WOLLSTONECRAFT PRECINCT ('Precinct')

SUBMISSION ON THE BEACHES LINK & GORE HILL FREEWAY EIS

Chapter 5: Project Description page 45 WHT&WFU EIS (2020)

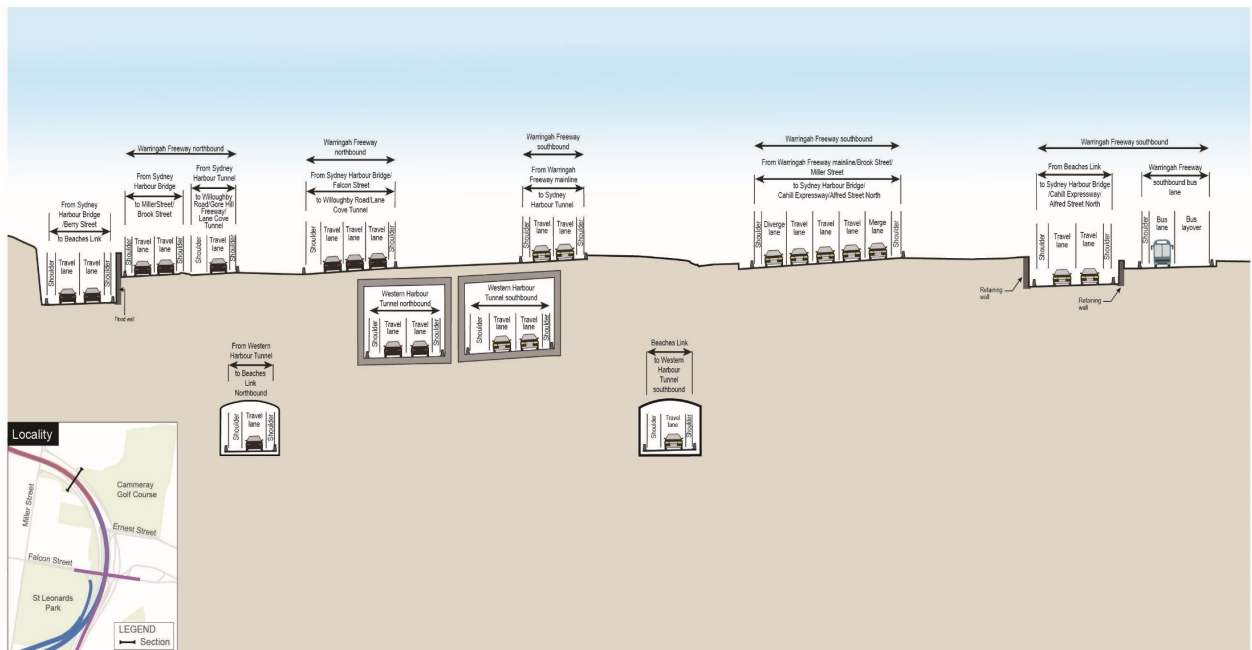
The WHT and BL projects are described in the EIS as “integrated” projects, this integration is limited to a single traffic lane connecting BL to WHT (see cross-section below) leaving the remaining two lanes to enter the Sydney CBD. This suggests that providing a link between the Northern Beaches and Sydney’s strategic motorway network (WestConnex) is now only a small part of BL’s intended function.
